Point-by-point reply to review by Dr. Chris Sioris

By Xi Xi on July 6, 2015

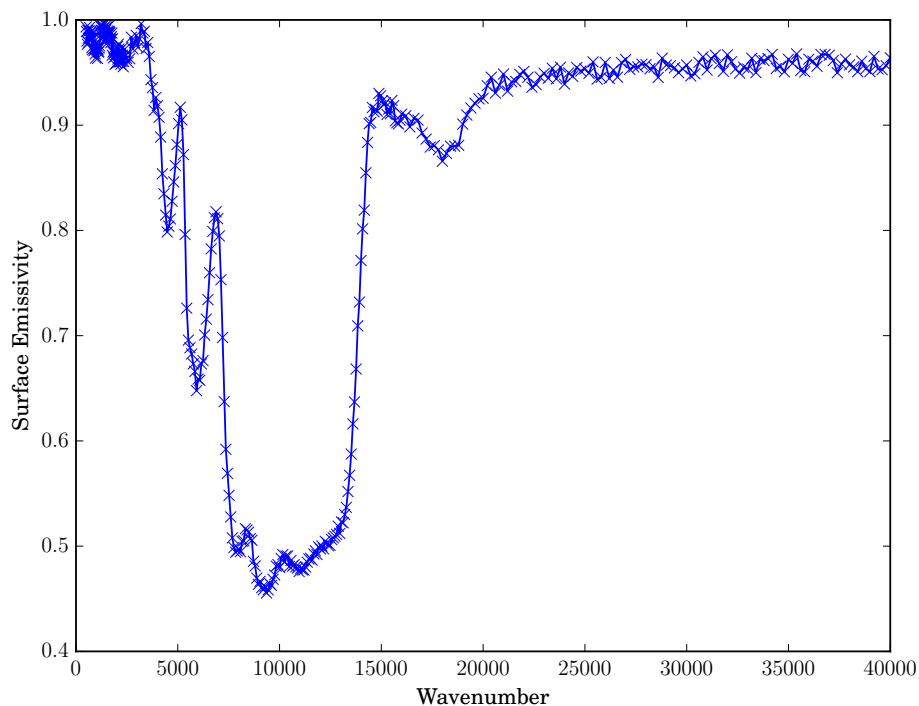
***Comment:** In the shortwave, the albedo of the surface is important (as is the bidirectional reflectance distribution) and the surface emissivity is not. Clearly at $1.6 \mu m$ and in the $O_2 A$ band, surface emissivity is not a factor. Yet surprisingly, the authors are able to retrieve it well given their DoF of 8.7 out of a possible 9. I am very surprised to see surface albedo missing from the state vector when it might be the most important state parameter for accurately modelling the radiance. Also, does the surface albedo vary from site to site? The range of surface albedos should be stated since this is important for understanding the influence of aerosols and clouds.*

Reply: There might be some misunderstanding here. For an opaque surface, surface albedo and emissivity must add to one, by Kirchhoff’s law: surface albedo = 1 - emissivity at a particular wavenumber. By retrieving a scaling factor for the surface emissivity, we are retrieving surface albedo indirectly. **We have added one sentence on P10L24 to clarify this point in the revised manuscript**. Yes, the surface emissivity and thus the surface albedo vary from site to site. And the surface albedos for other sites depend on the surface properties of each site. This was deemed to be known information and thus was omitted in the manuscript. **It has been added to P10L24 in the revised manuscript to clarify this point.**

The figure on the next page shows the emissivity at test location 1. Based on the emissivity, the surface albedos for test location 1 are as follows:

4210-4260 cm^{-1} : 0.134 to 0.147

4260-4320 cm^{-1} : 0.147 to 0.160

5950-6100 cm^{-1} : 0.348 to 0.341

6190-6260 cm^{-1} : 0.330 to 0.318
13000-13170 cm^{-1} : 0.483 to 0.474

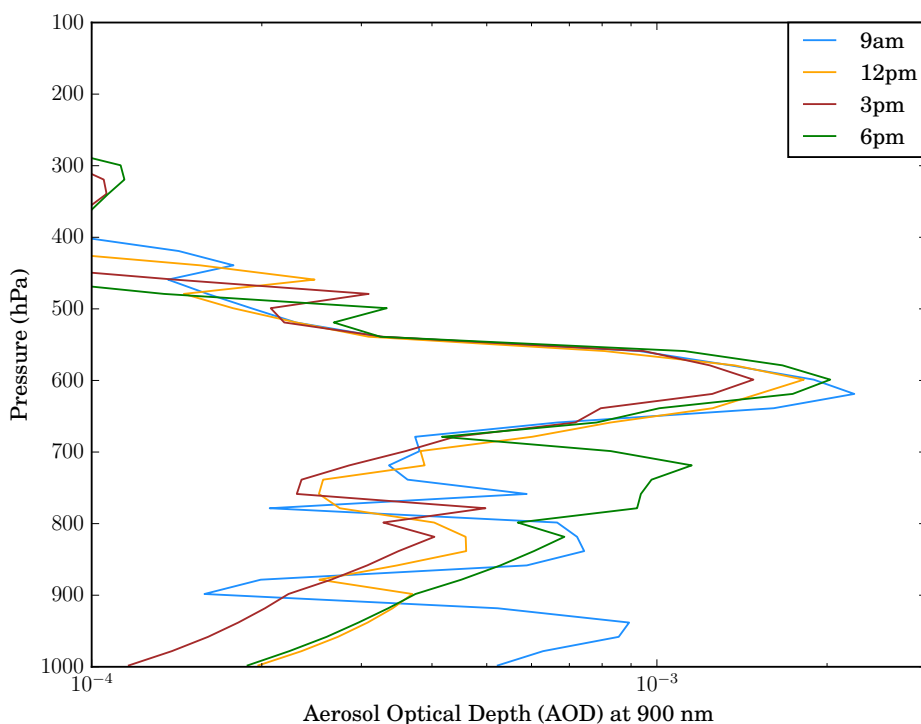
Comment: The aerosol loading for the all-sky cases are not clear. An input OD of 0.2 is mentioned in section 3.3 but the authors don't disclose the input OD for retrieval results reported in section 3.2. Rather than be quantitative, the authors state “small amount” on P5817L9 and “less than ~ 0.30 ” on p5824L23 and “small amount” again on P5826L20. This is not acceptable. Furthermore, “amount” is a vague term.

Reply: We would like to clarify that we did not intend to “cover up” the input OD for retrieval results. The input OD was not disclosed because this section was meant for a brief exploration on the influence of aerosols and clouds and the input OD is not new science to be presented. The figure on the next page shows the vertical profile of the aerosol optical depth at location 1. As this figure offers little new scientific insight to the reader, it was omitted from the manuscript. Again, this omission was not meant to cover up any undesirable details.

On P5817L9, the phrase “small amount” was used as a brief mentioning of the addition of aerosols and clouds to the model atmosphere. As section 2.2.1 is focusing on the forward model, we did not see the need to give the details of aerosols and clouds because they might deviate from the focus of this section. On P5824L23, “less than ~ 0.3 ” optical depth was the definition of the “small amount of aerosols and clouds” which pass through the pre-retrieval filtering. Because this is the amount of aerosols and clouds that a retrieval algorithm needs to deal with, we decided to study the total scattering OD that ranges from 0.0 to 0.20. On P5826L20, the “small amount of

aerosol and cloud contamination” is referring to total scattering optical depth less than ~ 0.30 . It is agreed that “amount” is a vague term. A more quantitative term is total scattering OD, as used in this study. The phrase “small amount” was meant as a reference to the total scattering OD below ~ 0.30 . **We have added one sentence to P15L8 in the revised manuscript to clarify this point.**

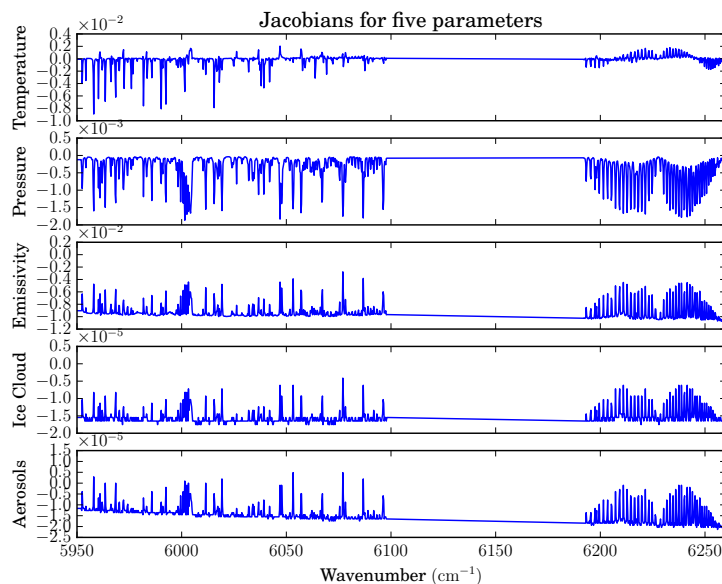
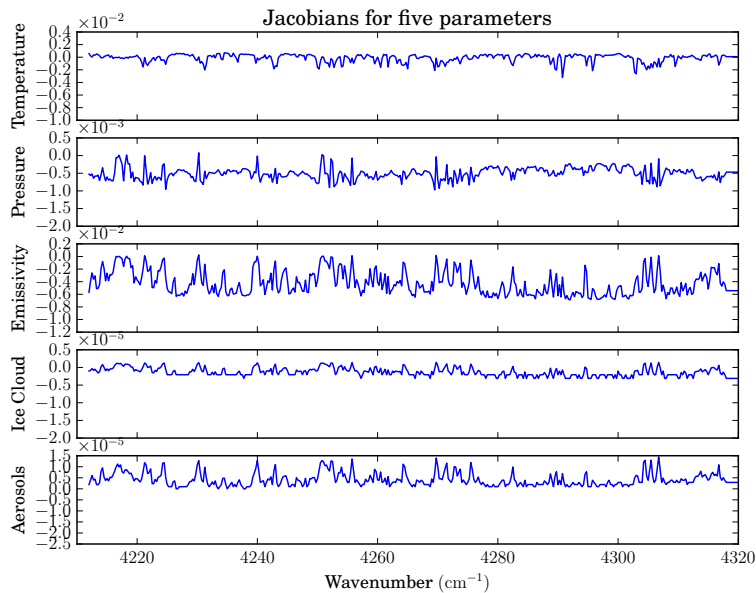
Comment: I would like to see the Jacobians for five of these other parameters: temperature, pressure, surface emissivity, clouds, and aerosols. I would like to see the correlation coefficient for aerosols and cloud Jacobians. Also, what is the correlation coefficient between the Jacobian spectrum for pressure and each of the following Jacobian spectra: CH₄, CO₂ and H₂O.

Reply: The figures below show the Jacobians for the five parameters. The correlation coefficients, r , are as follows: r (aerosol jacobian and cloud jacobian) = 0.91; r (pressure, CH₄) = 0.45; r (pressure, CO₂) = 0.53; r (pressure, H₂O) = 0.43.

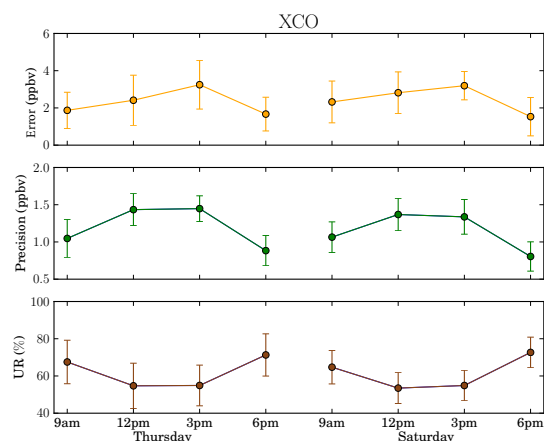
Comment: The authors could have explored the ability to detect the weekend effect in CO₂ or CO. Otherwise, what was the point of using two different days of the week?

Reply: We have analyzed the retrieval results over two different days of the week. The figure on the right shows the results for XCO over a Thursday and a Saturday. It shows that, regardless of the amount of CO during a weekday or a weekend day, the patterns for retrieval error and precision are similar. Therefore, we aggregated the results from different days to one single figure in Figure 7, instead of having one figure for each gas species. Figure 7 in the current manuscript is in a more condensed form and it still conveys the key scientific message.
